# Master Plan Amendments

## Master Plan Amendments

### Introduction

Original Plan

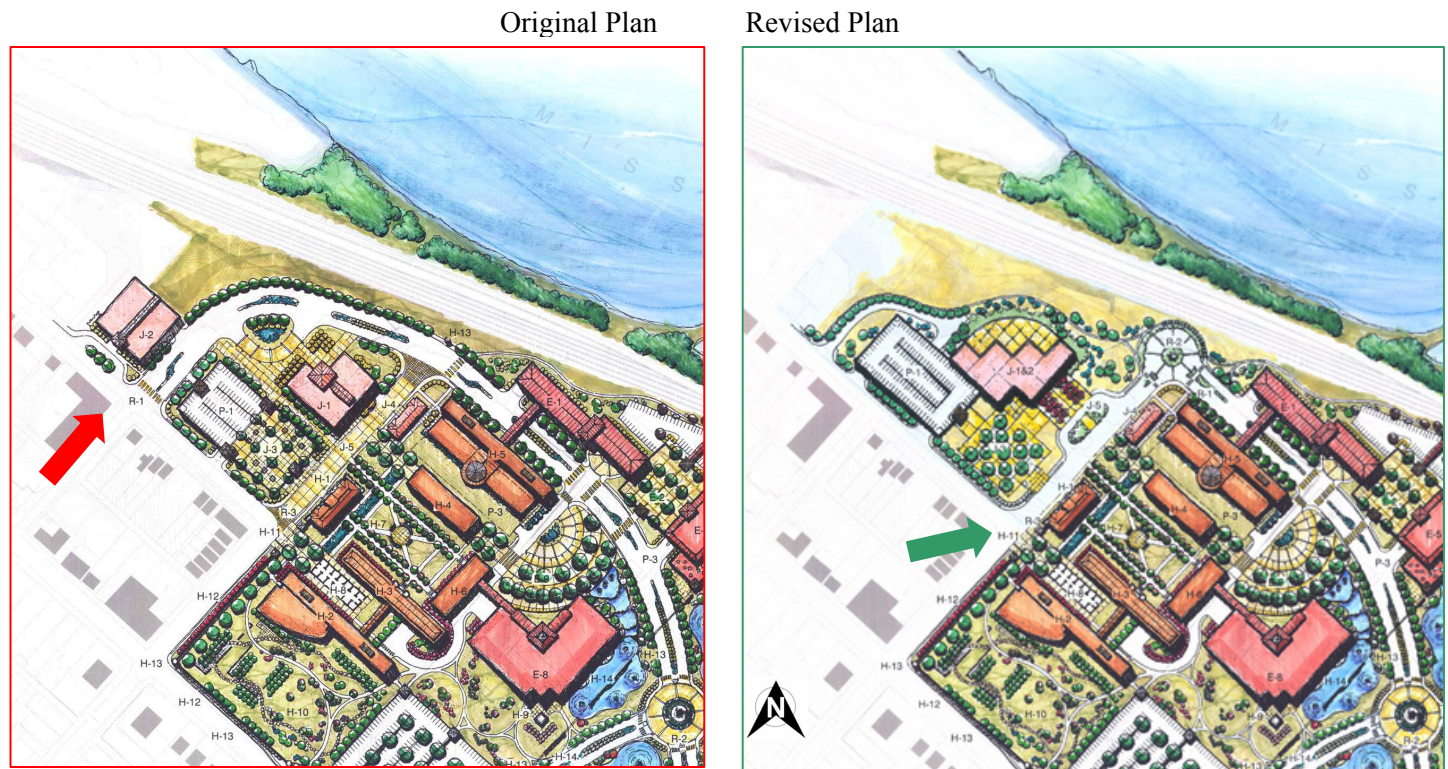
The Original Master Plan located the western entrance of the redevelopment project at the intersection of East State Street and Marshal Street. From there the proposed MSP Parkway would traverse the site from west to east. After further consideration the west entrance to the MSP Redevelopment Project was realigned along Lafayette Street and the Marshal Street connection was abandoned. The reasons for this change include:

- Lafayette Street appears to be a more desirable traffic connection to the west, south and east via the existing City street pattern.
- Sight distances and terrain are better at Lafayette Street than at Marshal Street.
- The Public Service Campus is no longer divided into two small parcels, but one larger tract making it more desirable for redevelopment.
- Lafayette Street was the original front door to the site.

The Master Plan has been updated to illustrate the final design footprint of the new State Health Lab located northeast and east of the intersection of Chestnut Street and East Capitol Street. The related changes include:

- Modified building footprint.
- Vehicular Circulation pattern modified to reflect functional aspects of the new building.
- The vehicular entrance to the P-2 structured parking has been moved south.
- A service drive has been added to the north side of the new building.
